Subject: Duke Energy Carolinas, LLC.
William States Lee III Nuclear Station - Docket Nos. 52-018 and 52-019
AP1000 Combined License Application for the
William States Lee III Nuclear Station Units 1 and 2
Request for Additional Information (RAI No. 1922)
Ltr# WLG2009.05-08

References: Letter from Tanya Simms (NRC) to Peter Hastings (Duke Energy),
*Request For Additional Information Letter No. 064 Related To SRP
Section 09.02.01 for the William States Lee III Units 1 and 2 Combined
License Application*, dated January 28, 2009

Lee Nuclear Station Response to Request for Additional Information (RAI)

NRC RAI Number: 09.02.01-5

WILLIAM STATES LEE III
 NUCLEAR STATION UNITS 1 & 2
 Raw Water System,
 River Water Subsystem
 FIGURE 9.2-201 Rev. 1

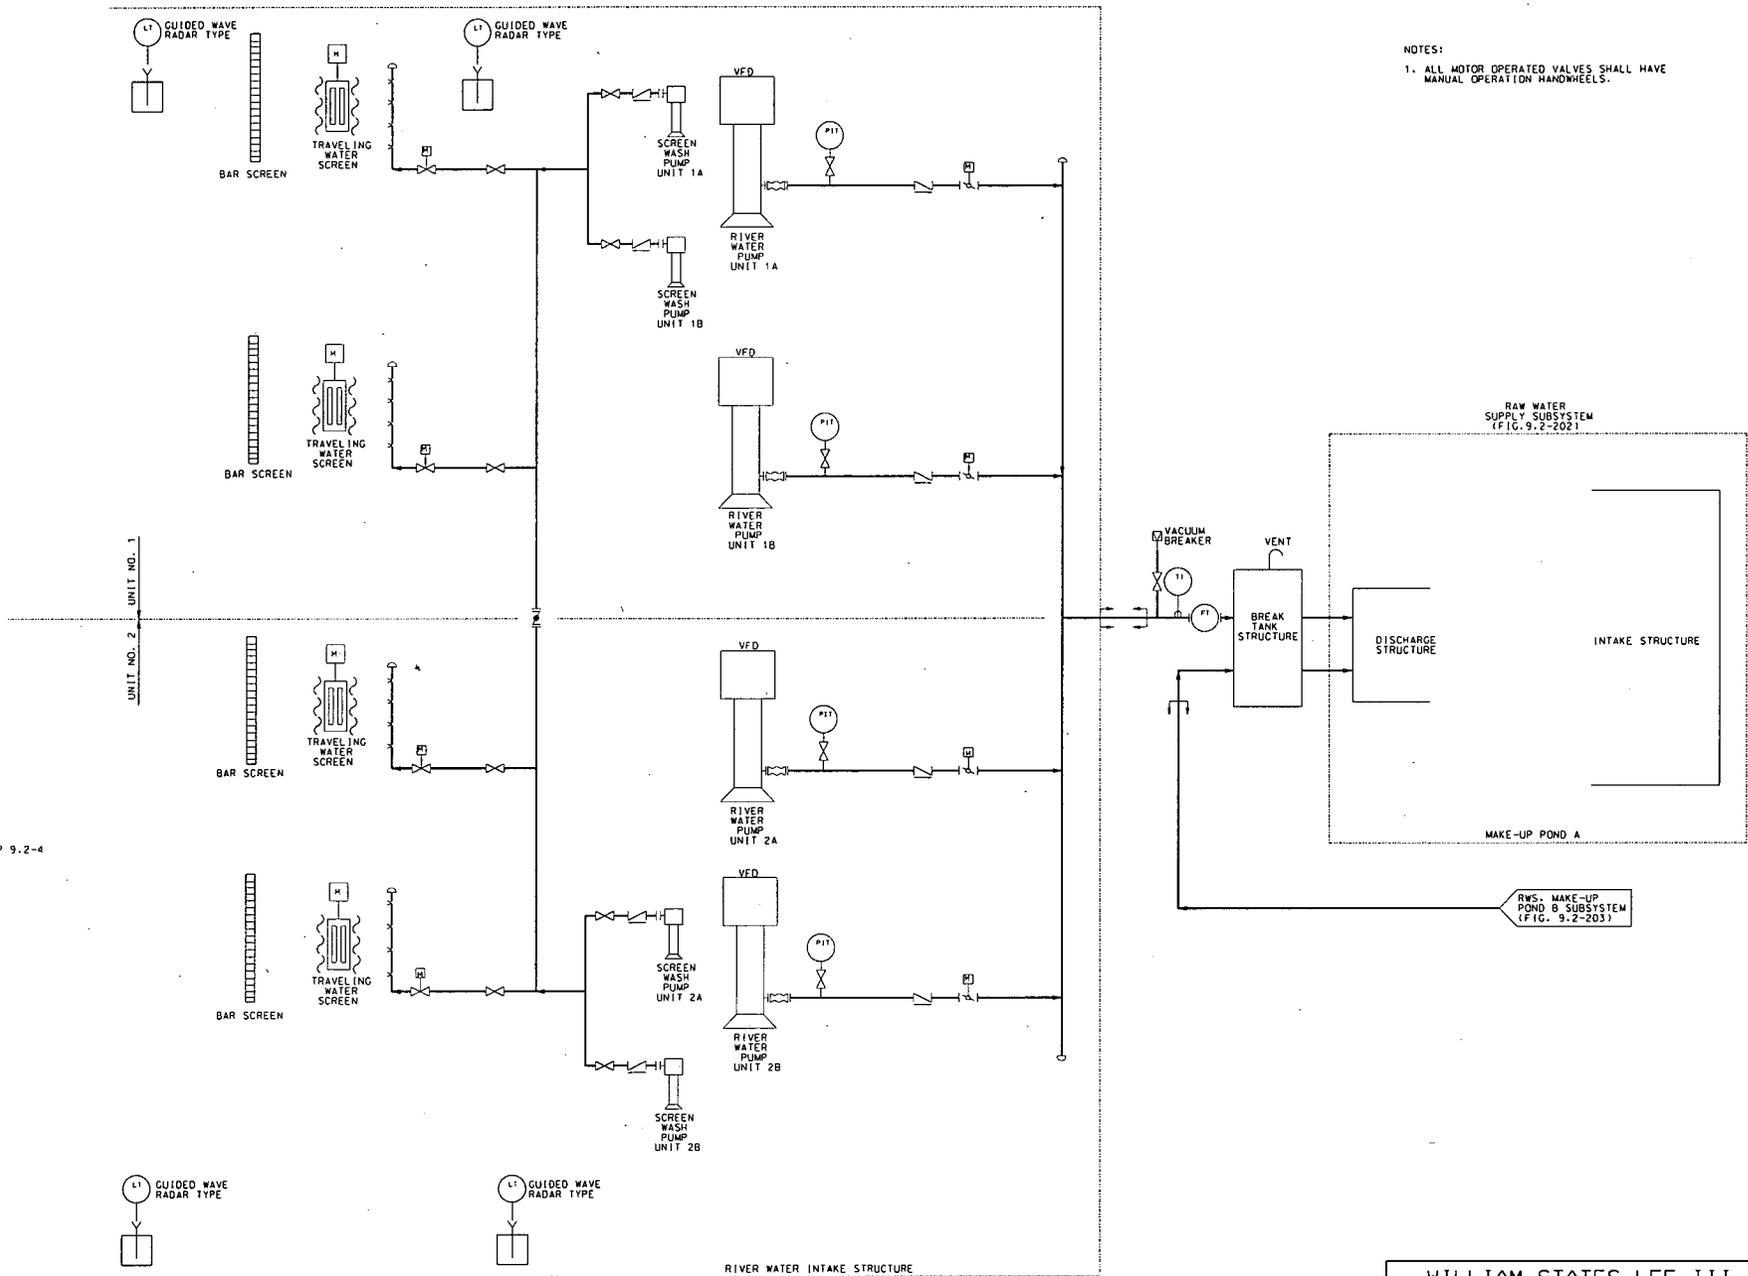
- h. System diagrams should show division designations, flow paths, major components and features, nominal pipe sizes, and instrumentation that is relied upon to ensure proper operation of the system by operators in the main control room and at the remote shutdown panels.

1. COLA Part 2, FSAR Chapter 9 replace:
 - Figure 9.2-201, Raw Water System, River Water Subsystem
 - Figure 9.2-202, Raw Water System, Raw Water Supply Subsystem
 - Figure 9.2-203, Raw Water System, Make-Up Pond B Subsystem
 - Figure 9.2-204, Raw Water System, Clarifier Subsystem and
 - Figure 9.2-205, Raw Water System, Clarified Water Supply Subsystem,

h.	Revised FSAR Subsection 9.2.11, Revised FSAR Figures 9.2-201 thru 9.2-205	FSAR Figures 9.2-201 thru 9.2-205 show the appropriate RWS system piping connections and appropriate interface breaks at proper locations. Division designations are not shown on the RWS flow diagrams. The RWS is non-divisional. The Figures identify instrumentation discussed in FSAR Subsection 9.2.11.
